Project: IEEE P802.15 Working Group for Wireless Personal Area Networks (WPANs)

Submission Title: [Proposal for MR-FSK 4-Level Preamble and SFD Values]

Re: [TG4g Letter Ballot 59 Comment Resolution]

Proposal for Filtered 4-FSK Preamble and SFD Values

- 6.3a.1.1 Preamble field (page 38)

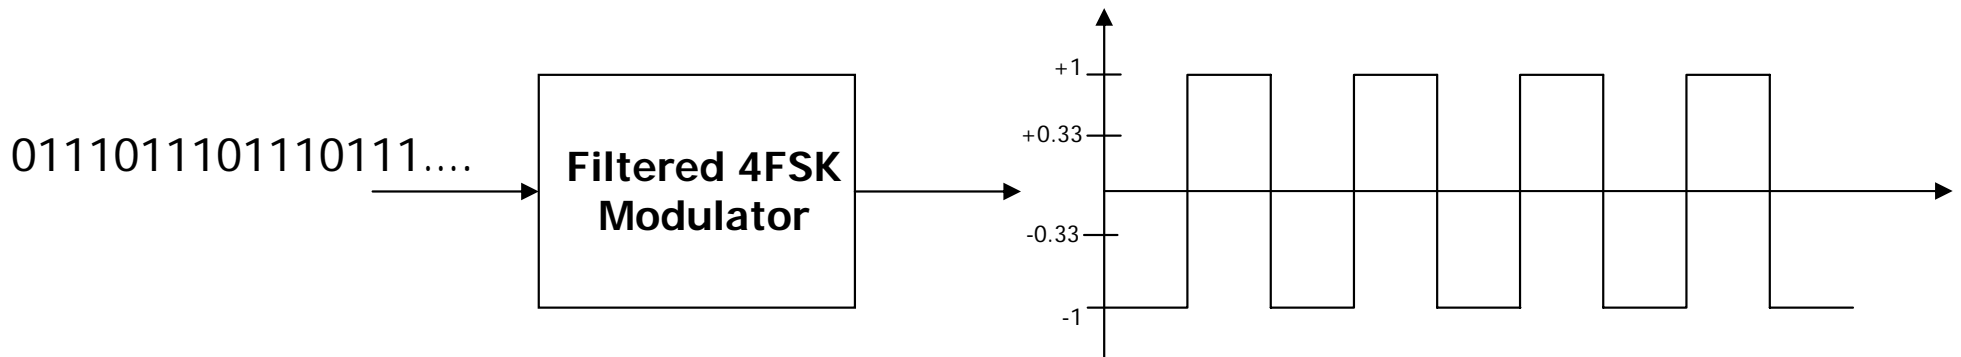
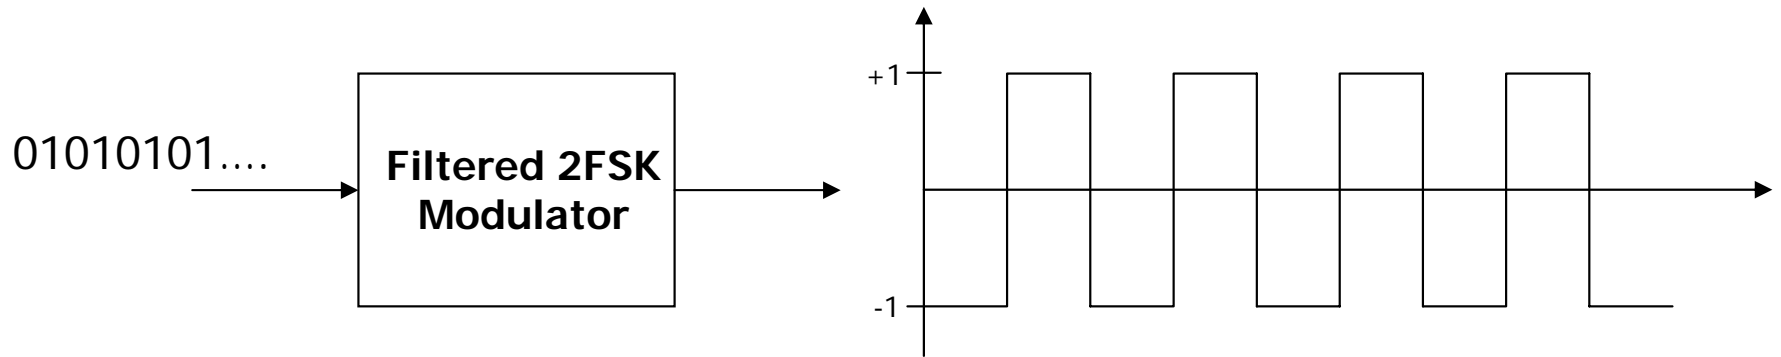
- The preamble and SFD values for 2-level filtered FSK are explicitly defined in the IEEE P802.15.4g/D2.
- The preamble and SFD for 4-level filtered FSK are specified but the values are not explicitly defined in the draft.
- To avoid ambiguity this proposal explicitly defines the preamble and SFD values for 4-level filtered FSK based on the definitions in the IEEE P802.15.4g/D2.
- Addressing the following comments:
CID#543 and CID#544

Proposed Change:

From

“The Preamble field shall contain phyFSKPreambleRepetitions multiples of the 8-bit sequence “01010101.””

to

“The Preamble field shall contain phyFSKPreambleRepetitions multiples of the 8-bit sequence “01010101” for filtered 2-FSK.

The Preamble field shall contain phyFSKPreambleRepetitions multiples of the 16-bit sequence “0111011101110111” for filtered 4-FSK.”

- This 4-level preamble sequence is functionally the same as the 2-level preamble sequence, and both preamble sequences have eight symbols.
